T&T Response to DLR Stage 2 Opinion

0086174DG0041

KILTERNAN VILLAGE DEVELOPMENT

Figure 3-1 - Construction Traffic Routes

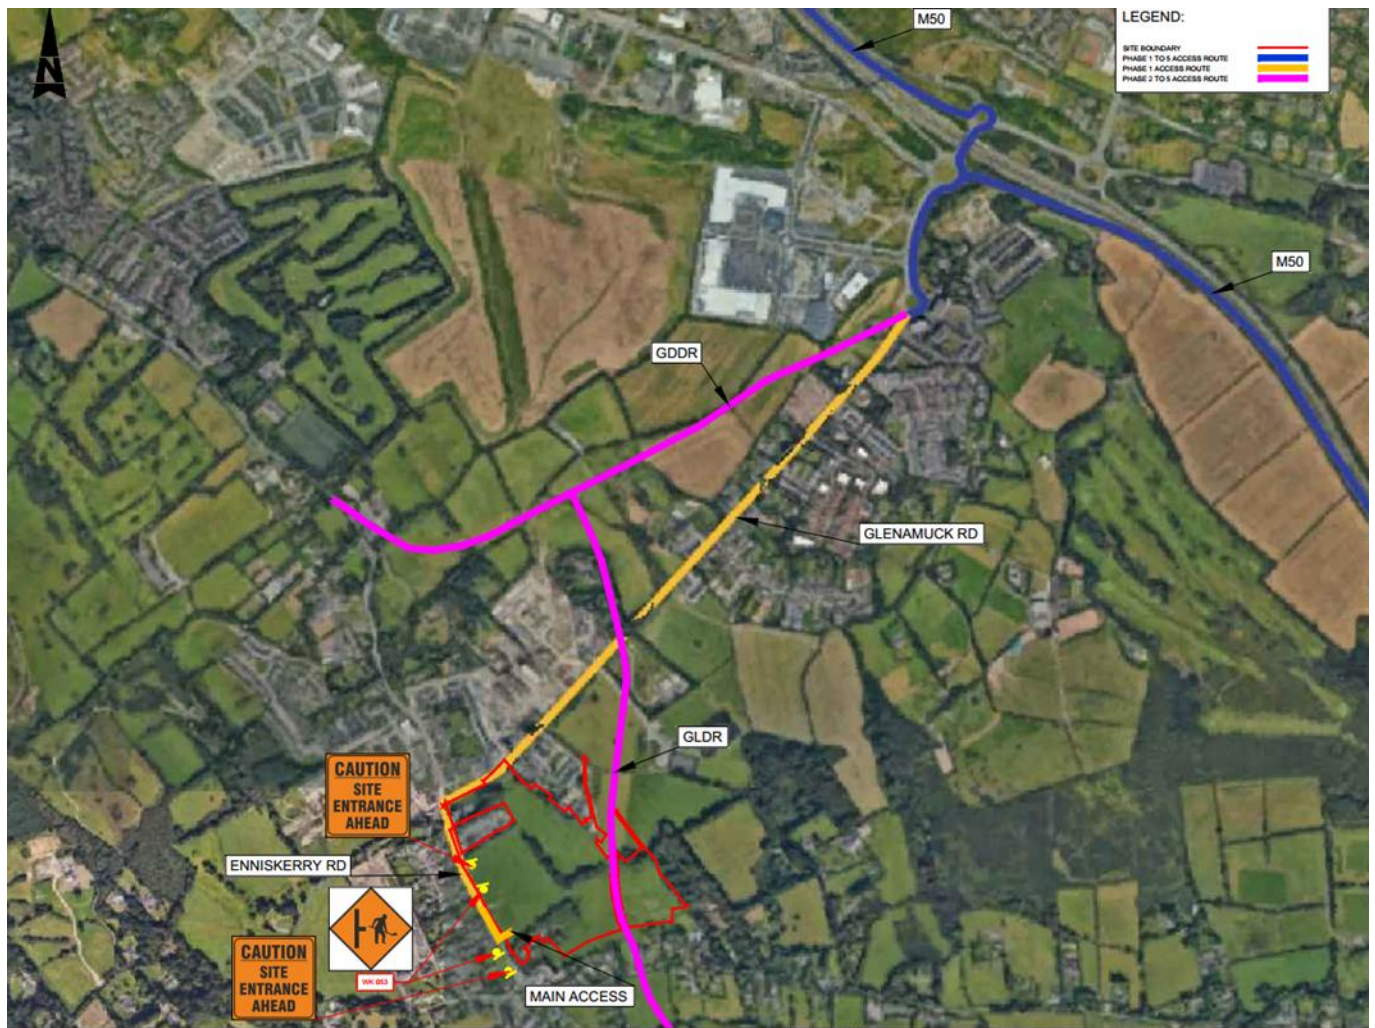
“Submission of a Construction Management Plan that takes into consideration the delivery of the proposed development and the construction of the Glenamuck Road District Distributor Scheme evidencing that the proposed development will not impact on the delivery of the new road scheme.”

Based on the GDRS programme, the GDDR would be in operation for a large portion of the construction phase. This would remove significant traffic volumes from the road network. During Phase 1, it has been assumed that the Glenamuck District Roads Scheme (GLDR) will not be available and construction traffic will follow the following route to access the site:

- M50 J15 – Glenamuck Road (R842) – Enniskerry Road (R117) – Site
- Construction traffic including heavy goods vehicles (HGVs) leaving the site will utilise the same route in reverse.

During Phase 2 and all later phases, once the GDRS scheme is available (anticipated in Q1 2026), construction traffic will access the site via the following route:

- M50 J50 – GDDR – GLDR – Site
- Construction traffic leaving the site will utilise the same route in reverse.

The construction traffic routing is illustrated in Figure 3-1 overleaf. As both the programme for the delivery of the GDRS and the LRD application may be subject to change due to unforeseen circumstances, the appoint main contractor would engage with the GDRS Project Team and other stakeholders to review, update and adjust the CMP as necessary to take account of any significant changes.

Figure 3-2 - GDA Cycle Network Plan

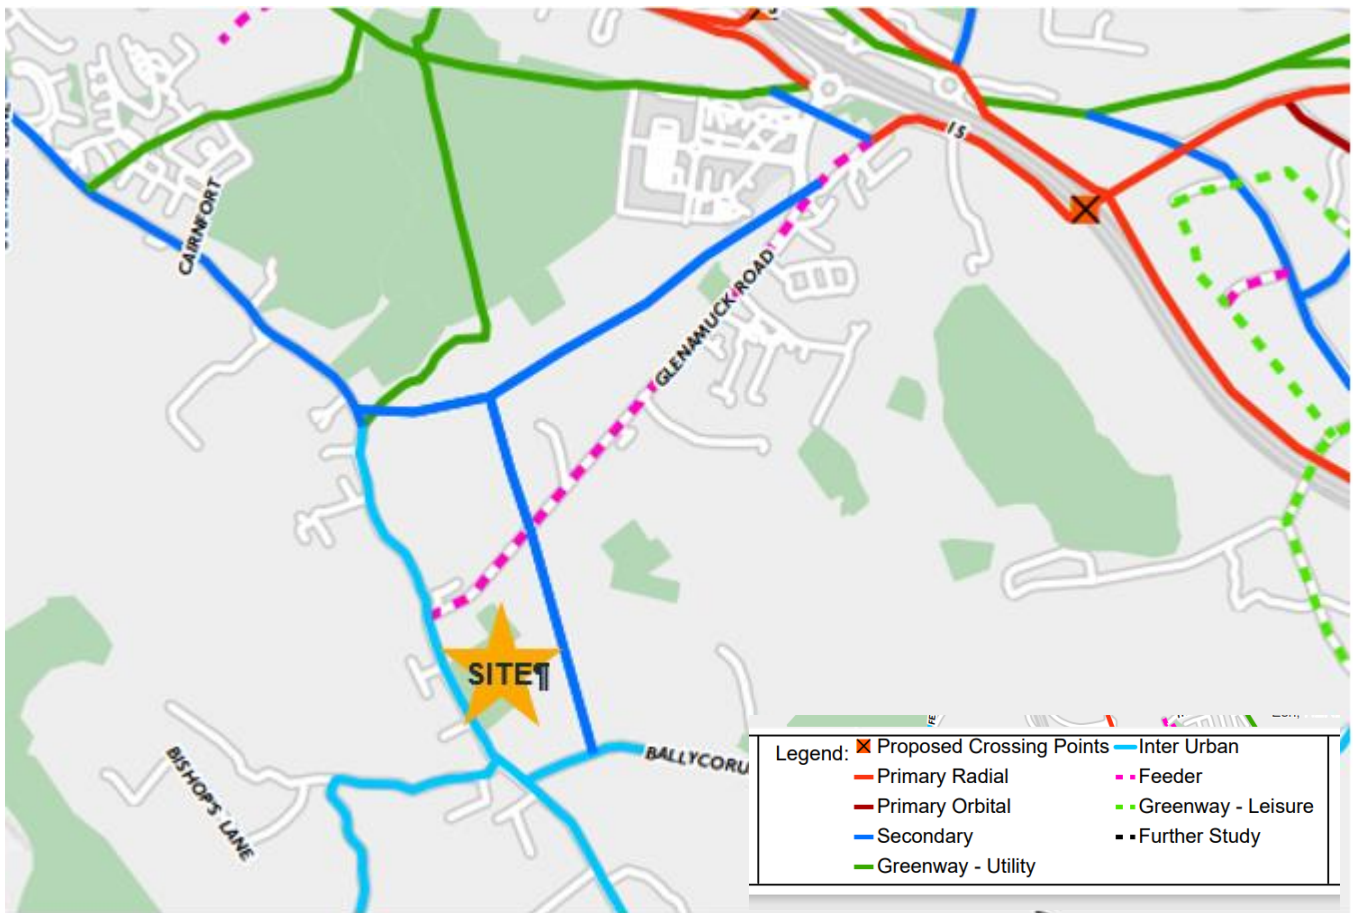
- b) *“The Applicant shall submit detailed drawings and information which clearly demonstrate that the proposed development accords with the 2022 Greater Dublin Area Cycle Network Plan 2022. The Applicant shall also demonstrate the full range of pedestrian permeability and connectivity across the site. Continuous, legible routes should be provided for pedestrians & cyclists from each dwelling which prioritise pedestrian and cyclist movements in accordance with the requirements outlined within DMURS. The design shall also cater for pedestrian desire lines across the site.”*

Section 4.3 and Figure 4-4 of the Traffic and Transport Assessment set out the future Greater Dublin Area (GDA) Cycle Network plans for the area. This is shown in Figure 3-2 - GDA Cycle Network Plan overleaf for ease of reference. The GDA Cycle Network Plan proposals and the proposed connections to them consists of:

- Secondary Cycle Routes – located on the GDDR and GDLR that make up the GDRS scheme. Fully segregated cycle facilities are provided for a part of the GDRS scheme. A direct connection to the GDLR is provided as part of the proposed development. This includes the provision of cycle connectivity.

- Feeder Cycle Route – located on Glenamuck Road. Fully segregated cycle facilities are provided along the Glenamuck Road through the Part 8 proposals that are being provided as part of the delivery of the GDRS scheme. Direct connections to the Glenamuck Road from the proposed development are proposed affording good cycle connections for future users of the development.

- Inter Urban Cycle Route – located on Enniskerry Road, Ballybetagh Road and Ballycorus Road. As a result of the GDRS and the proposed bus gate on Enniskerry Road, traffic flows will be greatly reduced on Enniskerry Road fronting the site. In this lower volumed lower speed environment cycling in mixed traffic would be suitable. A number of connections from the proposed development are proposed onto Enniskerry Road.

Figure 3-4 - Extract showing Cycle Parking Location and Layout

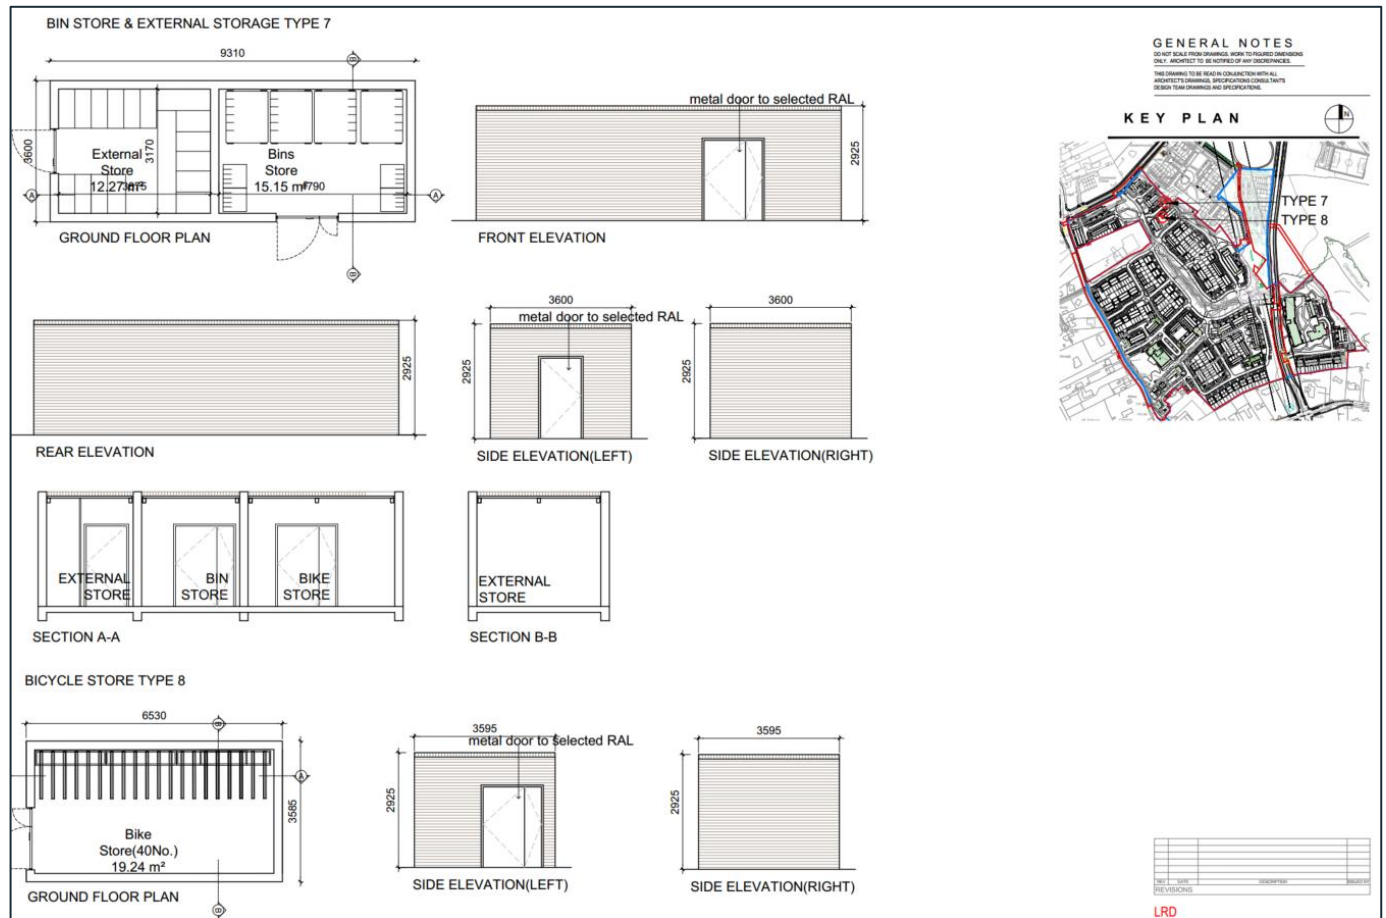
- c) *“The Applicant shall submit drawings and details which demonstrate that the level of provision of cycle parking is in accordance with the required quantities outlined within Table 4.2 of DLRCC’s Standards for Cycle Parking and associated Cycling Facilities for New Developments (January 2018). A submitted standalone detailed drawing which demonstrates all proposed provision and allocation should be submitted. The non-residential provision shall be clarified in relation to GFA (Gross Floor Area) and Staff numbers.”*

The location and layouts for the proposed dedicated cycle parking are detailed on MCORM drawings PL608 to PL611 – Bin and Bike Stores and PL601 Parking Layout. An extract from one of those drawings is shown in Figure 3-4.
